## **THE ESTATES AT MAGNOLIA GROVE SUBDIVISION**

APPLICATION NUMBER 27 DATE August 16, 2007

REQUEST Subdivision

## DETAIL SITE PLAN

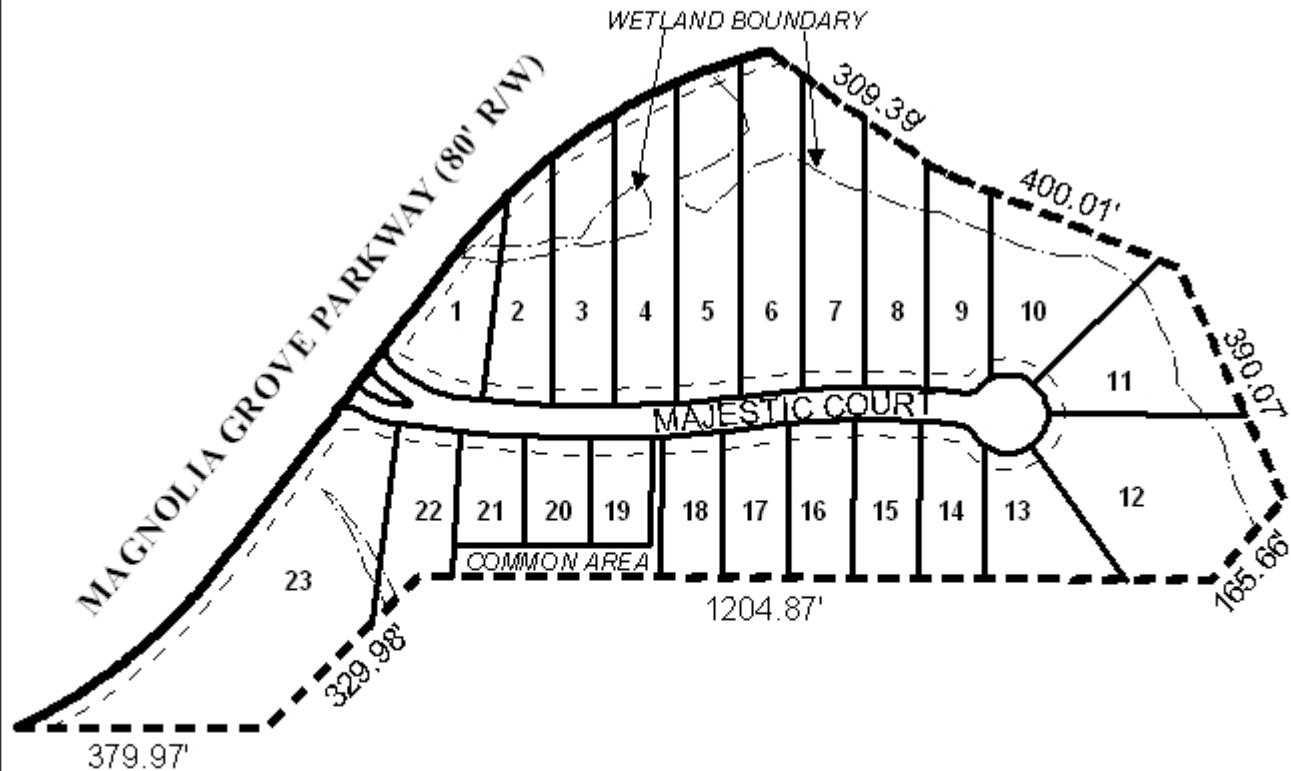
Access management is a concern due to lots 1 through 6 having double frontage (both the front and the rear of the property abut public rights-of-way), and 23 being a corner lot with significant frontage (side) on Magnolia Grove Parkway. A note should be placed on the plat stating that direct access to Magnolia Grove Parkway is denied for all lots. A note should also be placed on the plat stating that each lot is limited to one curb-cut each, with the size, design and location to be approved by Traffic Engineering and conform with AASHTO standards.

The 25-foot minimum building setback line, required in Section V.D.9., is shown but not labeled for most of the lots within the subdivision, however, it also should be depicted for

those lots with rear frontage along Magnolia Grove Parkway. The plat should be revised to show and identify the setback line from all street right-of-ways.

A common area for detention is depicted on the plat, as is a common area at the entrance to the subdivision. A note on the preliminary plat states that all commons area will be maintained by the property owners association, and should remain on the Final Plat, if approved.

A portion of the site contains wetlands. The presence of wetlands indicates that the area may be environmentally sensitive; therefore, the approval of all applicable federal, state and local agencies would be required prior to the issuance of any permits or land disturbance activities.

The proposed street will exceed the maximum length of a closed-end street as recommended by the Subdivision Regulations; however, given the configuration of the wetlands and the surrounding development, a waiver of Section V.B.6. is recommended. Additionally, as is typical with lots similarly situated, Lots 2-9 exceed the maximum width to depth ratio recommended by the Regulations, thus a waiver of Section V.D.3., is also recommended. Each lot is labeled with its size in square feet, and such labeling should remain on the Final Plat, if approved.

As no PUD was submitted to allow reduced setbacks or increased site coverage, standard Zoning Ordinance requirements will be applied and should be so noted on the plat, especially given the size of the lots.

- 1) placement of a note on the final plat stating that direct access to Magnolia Grove Parkway is denied for Lots 1-6 and 23;
- 2) placement of a note on the final plat stating that each lot is limited to one curb-cut each, with the size, design and location to be approved by Traffic Engineering and conform with AASHTO standards;
- 3) revision of the plat to show and identify the setback line from all street right-of-ways;
- 4) the note on the preliminary plat stating that all commons area will be maintained by the property owners association remain on the Final Plat;
- 5) placement of a note on the final plat stating that standard Zoning Ordinance setback and site coverage requirements will be applicable to all lots; and
- 6) approval of all applicable federal, state and local agencies prior to the issuance of any permits or land disturbance activities.
